The Beach – Apollo Bay

Development Plan Summary

17 January 2018

Beveridge Williams Melbourne Office 1 Glenferrie Road Malvern Vic 3144 PO Box 61 Malvern Vic 3144 Tel: (03) 9524 8888 beveridgewilliams.com.au	Title	Development Plan Summary
	Author	Leanne Nickels
	Checked	Mark Fleming
	Project Manager	Bernard Stewart
	Synopsis	Brief report discussing the revised development plan

APPENDIX F. Indicative Landslip Protection Measures

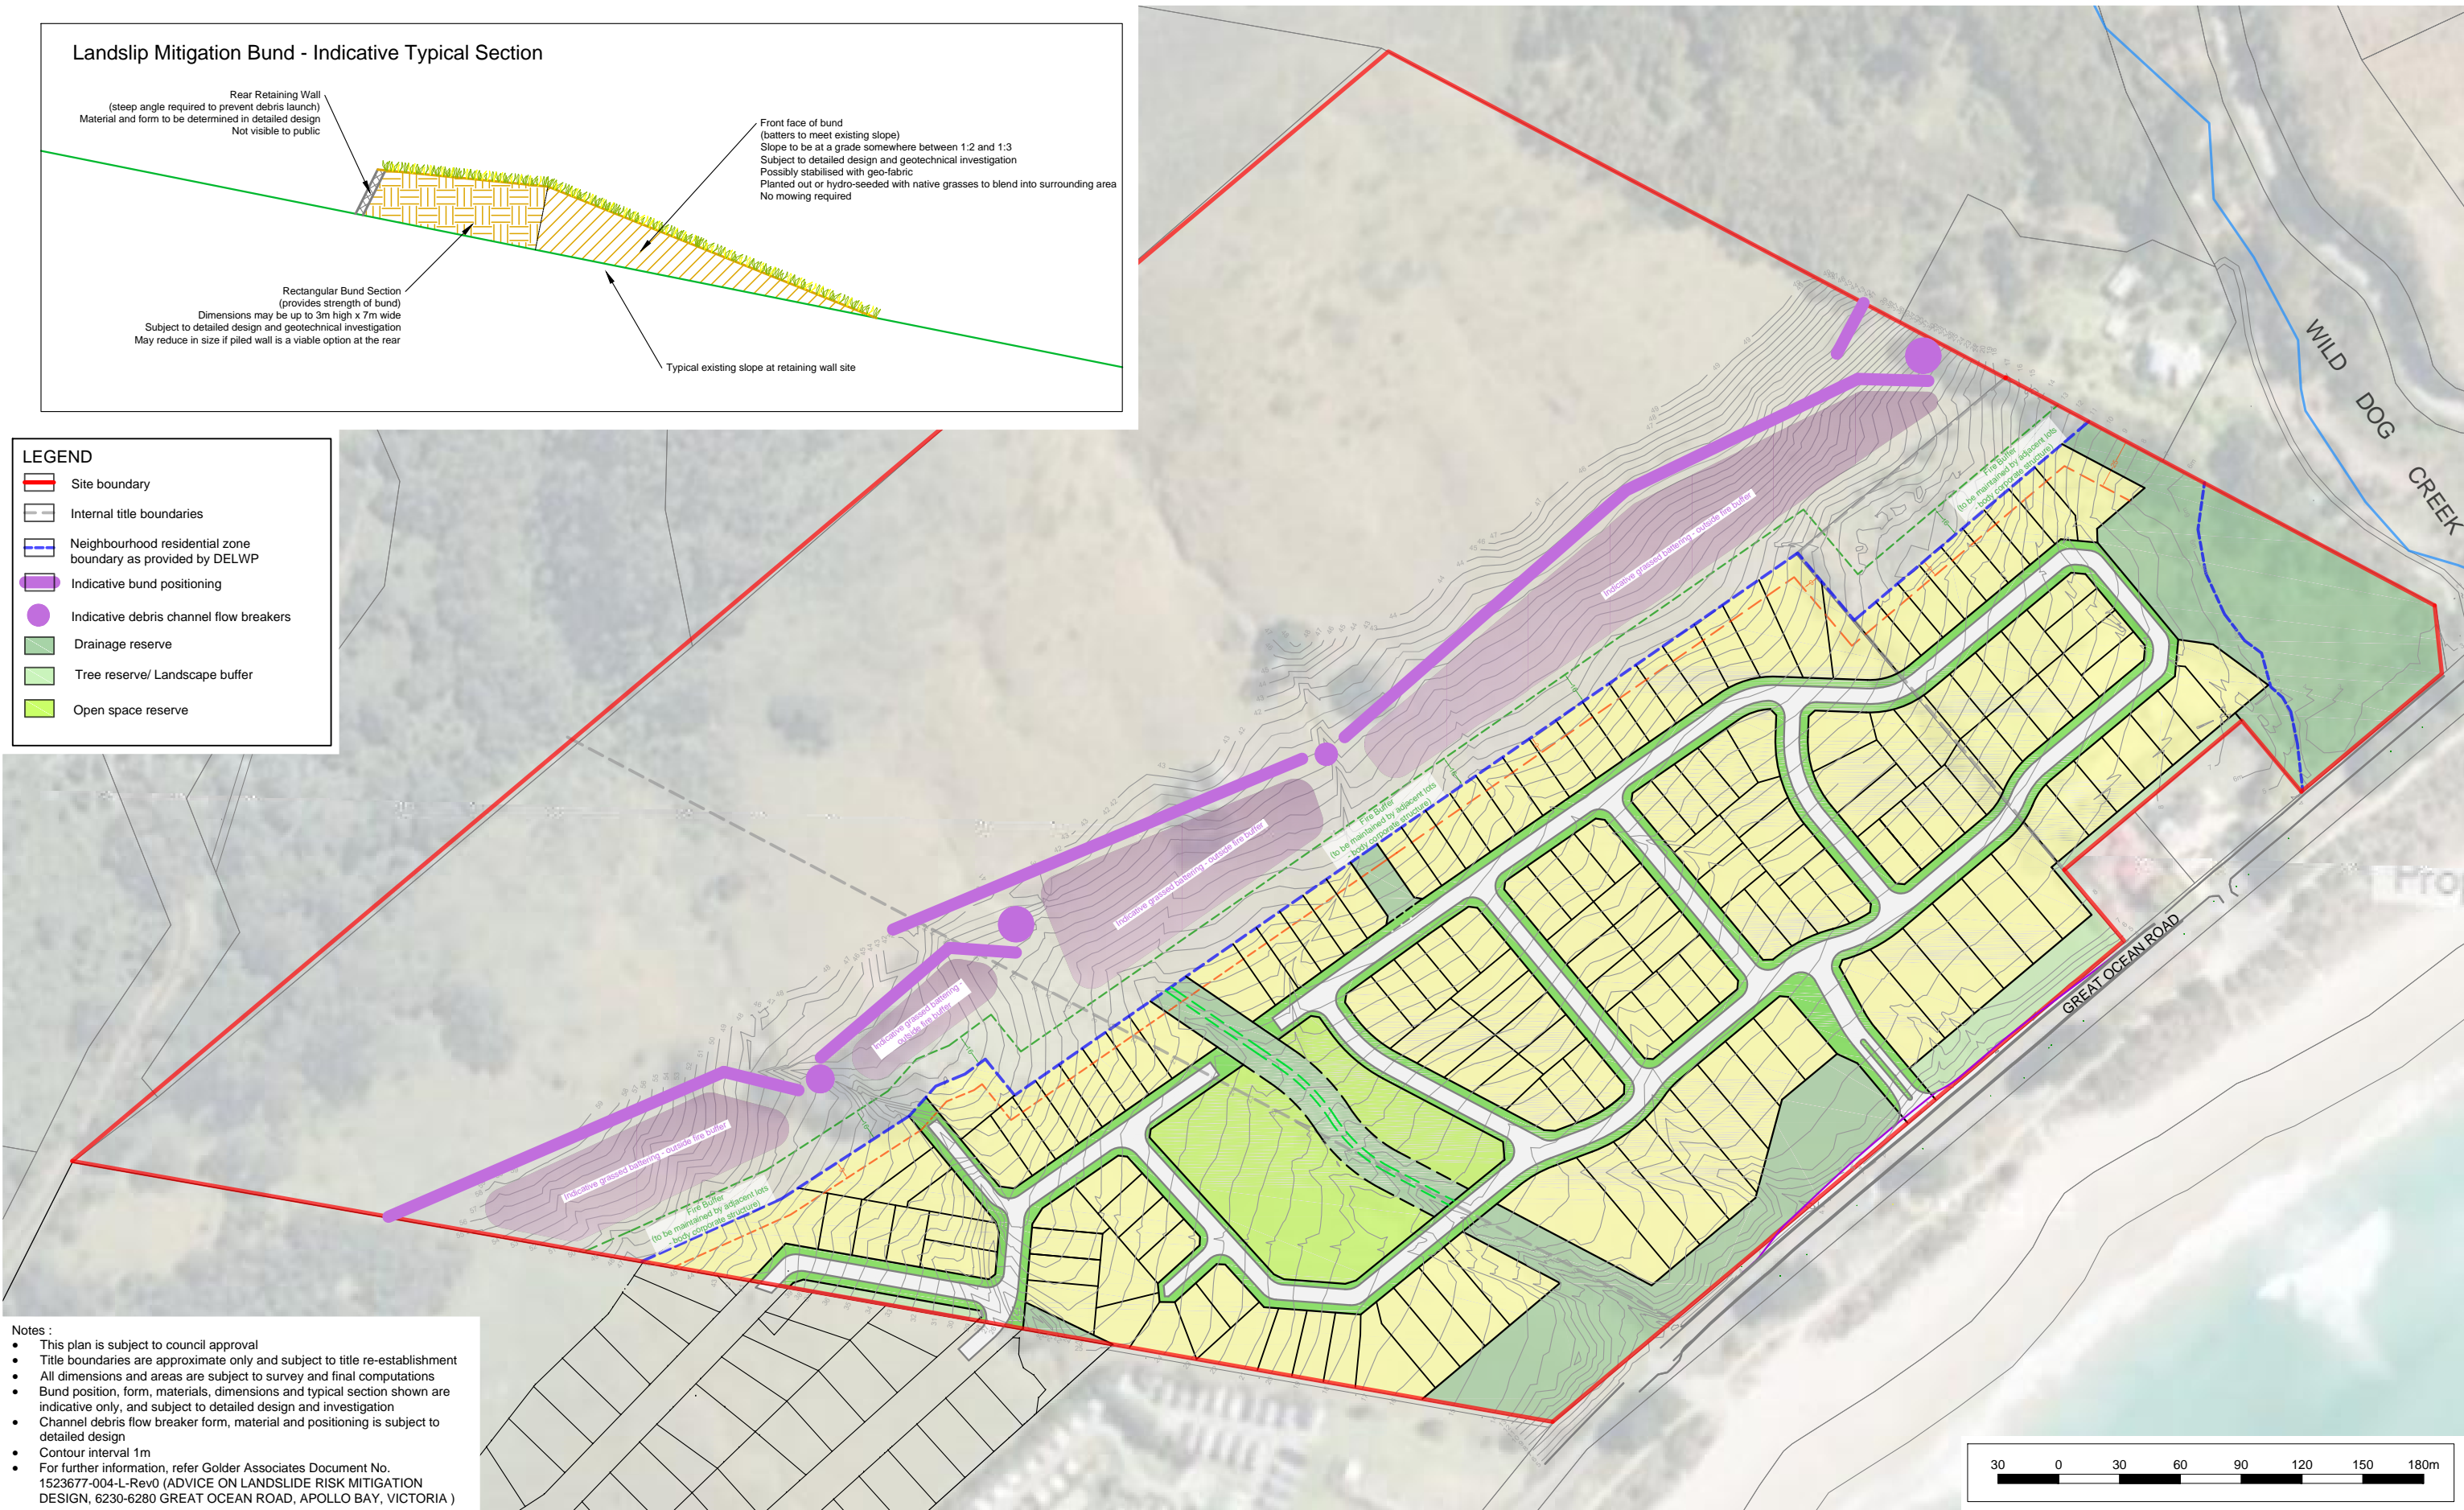
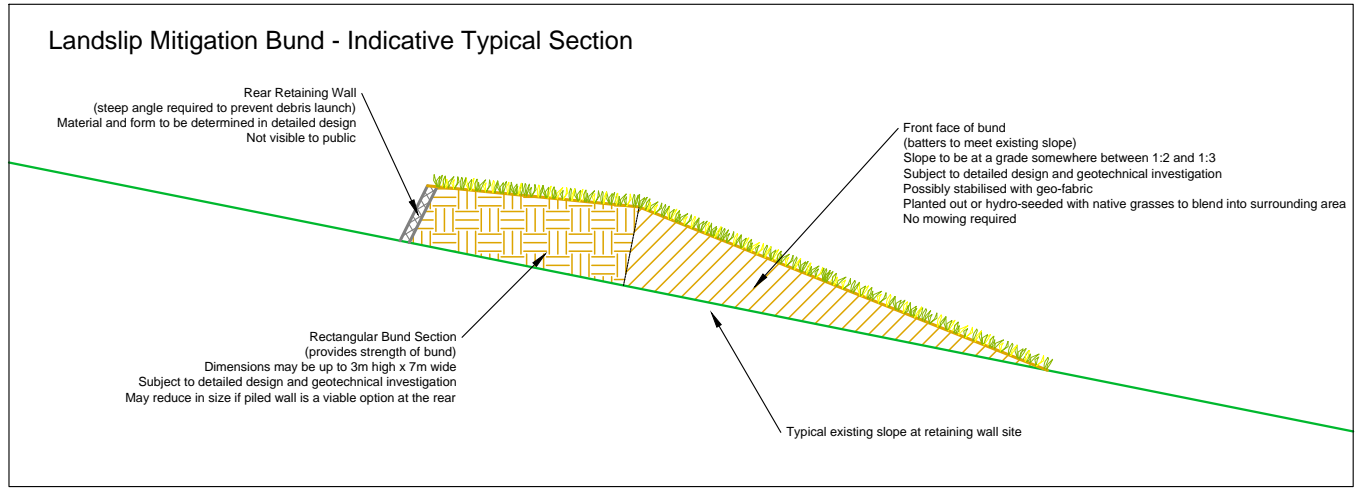
The process of obtaining professional advice so as to form a more detailed idea of the proposed bund's size, aesthetic and position has been initiated. An initial report has been received and the developer is now undertaking further investigation of the options presented, so a decision on the final form of the bund can be made.

Based on professional advice received from Golder Associates an initial concept for the size, form and positioning of the proposed earth bund has been put together.

It is proposed that the bund is formed with a rear retaining wall structure facing up the slope, to prevent debris "launching" over the bund. This side of the bund will not be visible to the public and so aesthetics are not as important in this area.

Initial calculations show that the functional part of the bund may require dimensions in the order of 3m high and 7m wide. There is the possibility of reducing this size if a pile-driven wall can be located at the rear of the bund. The viability of this would be subject to onsite geotechnical investigations and cost assessments.

Due to the fall of the site, relatively steep (1 in 2 to 1 in 3 grade) slopes will be required in front of the functional part of the bund in order to batter back to the existing slope. Grades need to be around 1 in 6 for mowing to take place. For this reason, it is proposed to relocate the bund and battering further back in the site, outside of the required fire buffer. This will allow the bund to be planted out or hydro-seeded with native grasses, to match the surrounding area, which will not require mowing. Depending on the grades required, geo-fabric may be investigated to provide extra stability on the front slopes of the bund.

Advice from Golders has recommended that where landslide debris flow may enter existing channels and flow into the developed portion of the site via roads and drainage flow paths, breaker zones be placed, consisting of driven piles, to break up the debris flow. The actual sizing, form and position of the breaker zones will be subject to detailed design. An additional breaker zone and drainage flow path has been added in the eastern portion of the site, to allow for debris flows to remain on the subject property, without impacting any allotments.

APPENDIX G. Indicative Stormwater Management Plan

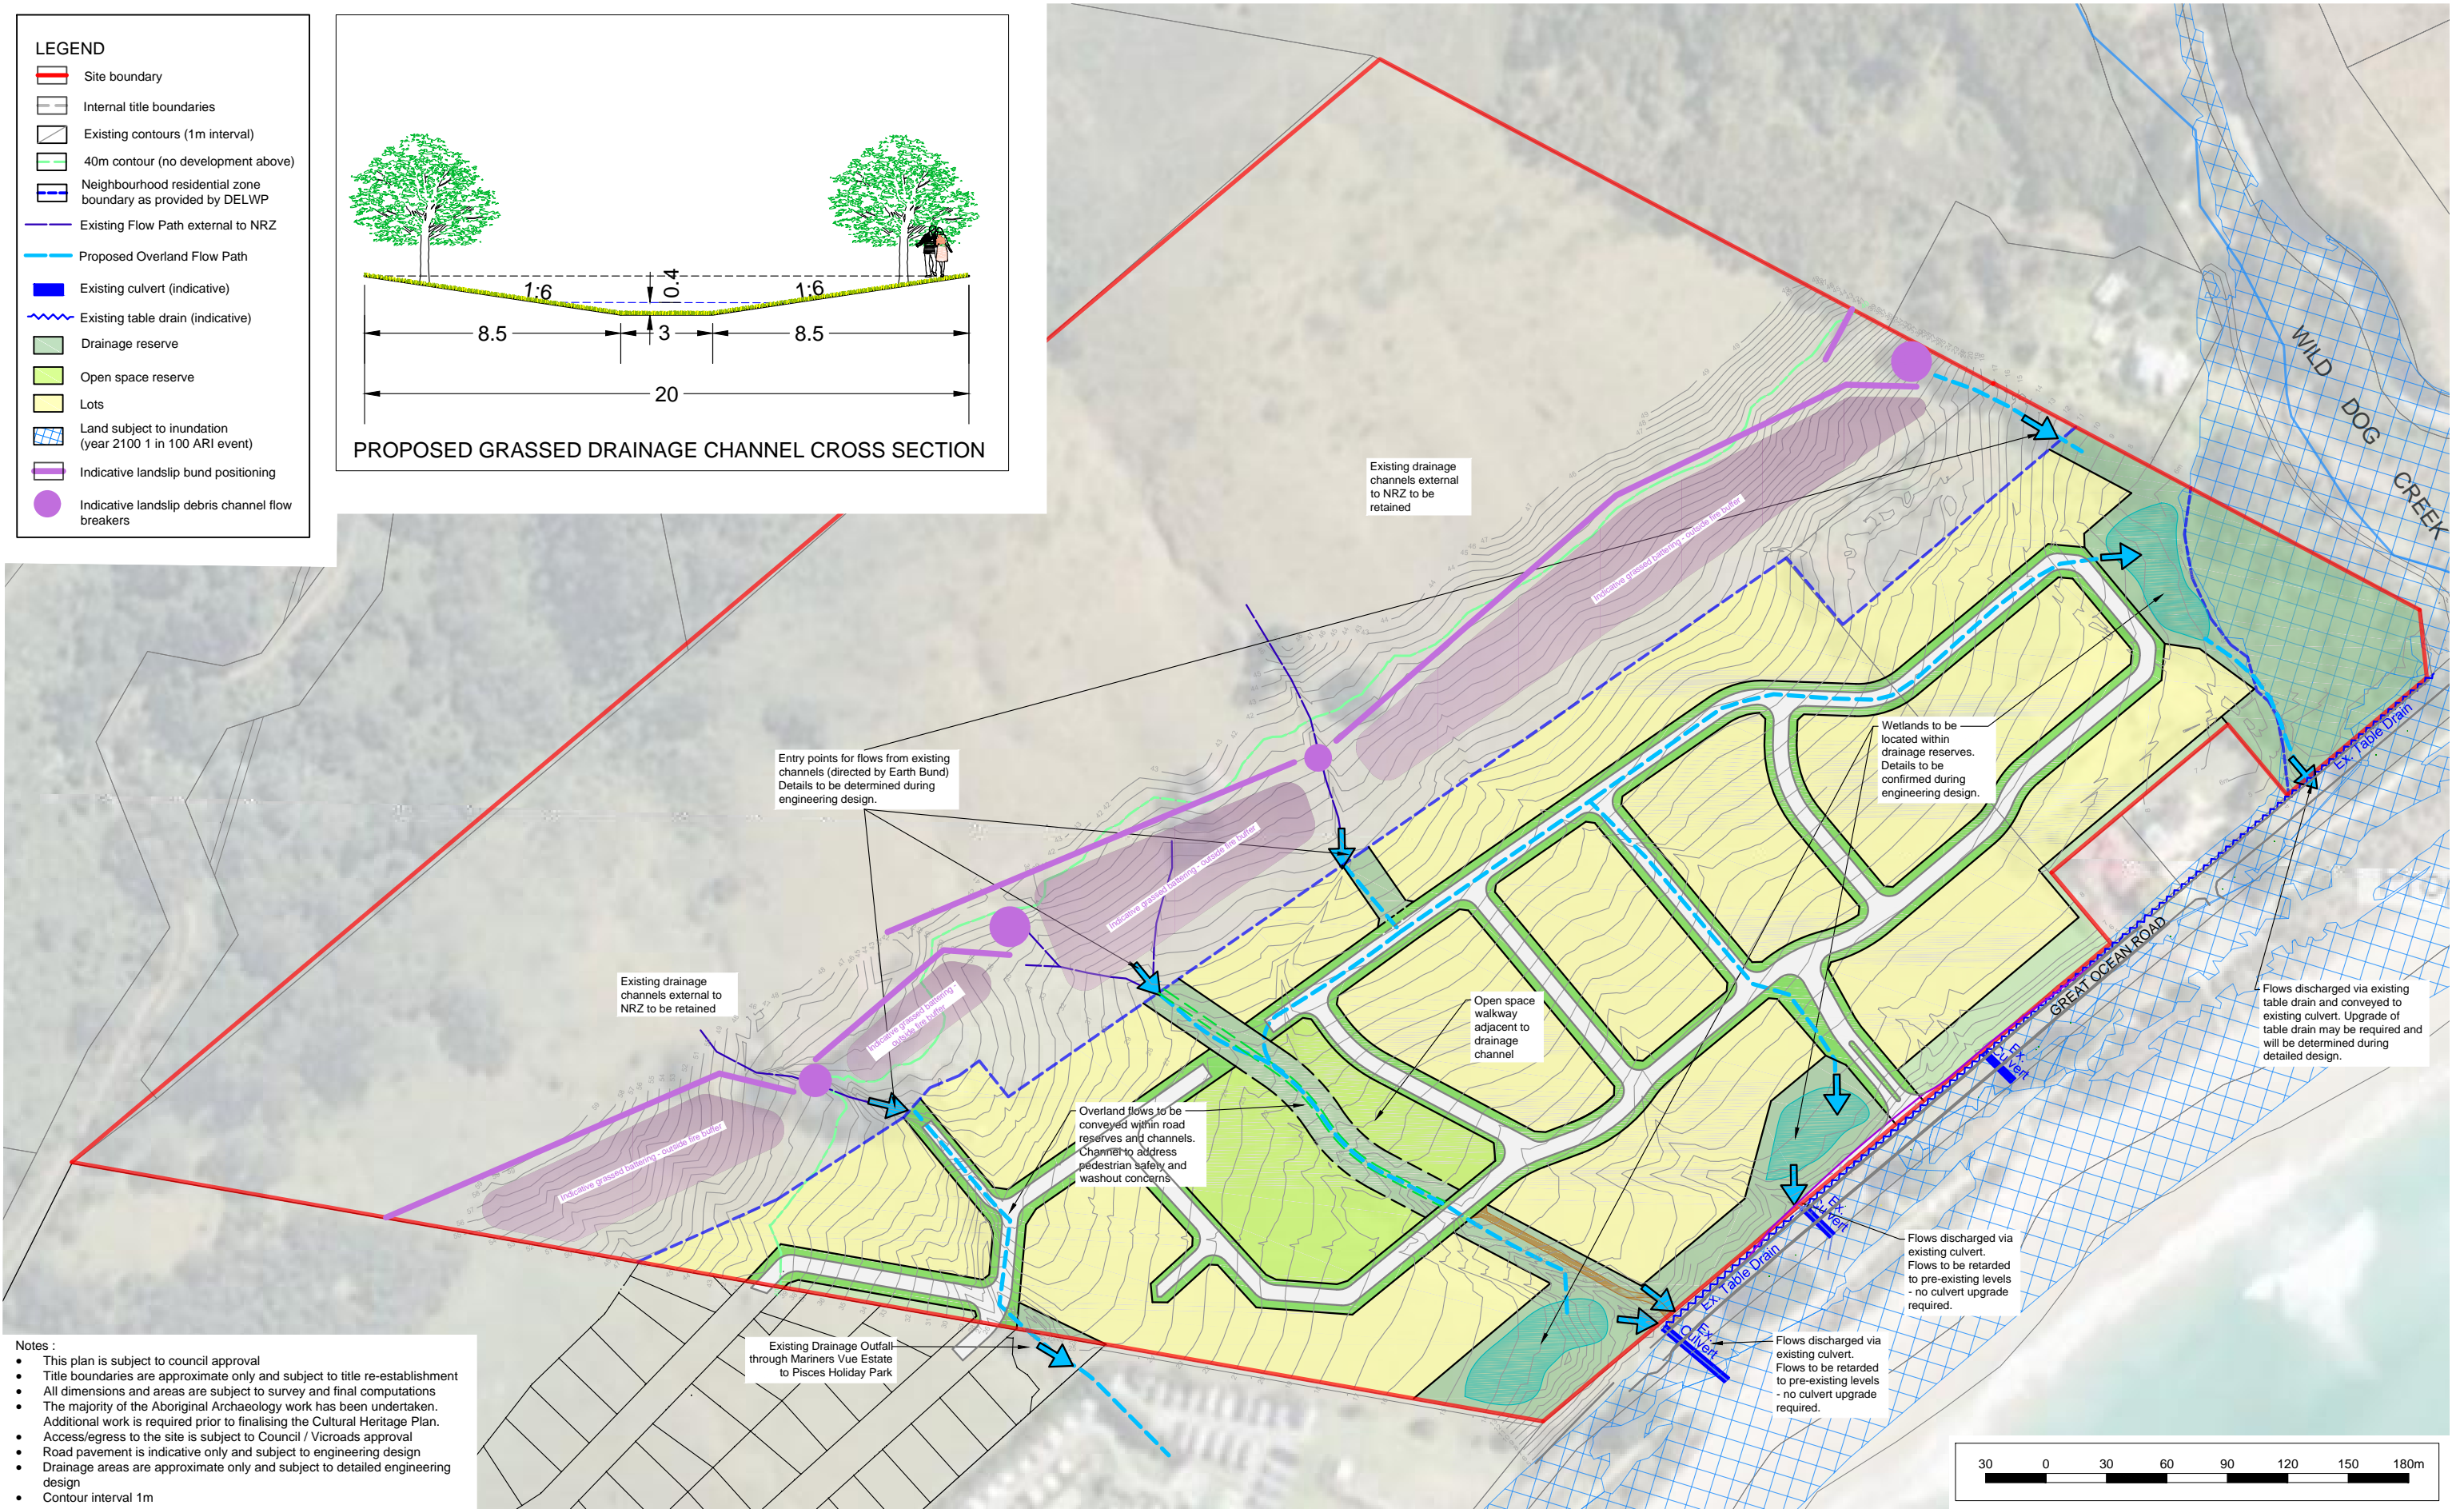
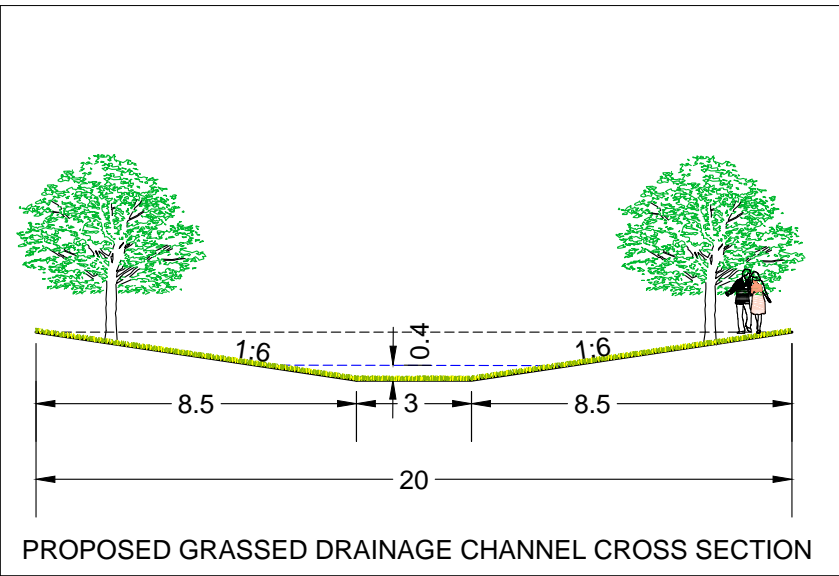
The plan attached in appendix G demonstrates that existing overland flow routes through the site are to be maintained. Small overland flow reserves have been placed at the existing entry routes of overland flows into the area to be developed. Together with road grading, these will allow the overland flows to be directed either offsite to Mariners Vue drainage reserve, or along the central drainage channel to be provided within the proposed open space.

6.1a Response following meeting with Council – November 2017

At the meeting, Council Officers expressed concern at the narrow width of the channel at the northern entry point to the developed area. In response, the development plan now shows the channel extending through at a consistent width. Additionally, the northern road crossing the drainage channel has been converted into two non-joining T-heads, allowing for the removal of a culvert crossing, and presenting the added benefit of removing a long, unrestricted section of road, improving speed control within the local area.
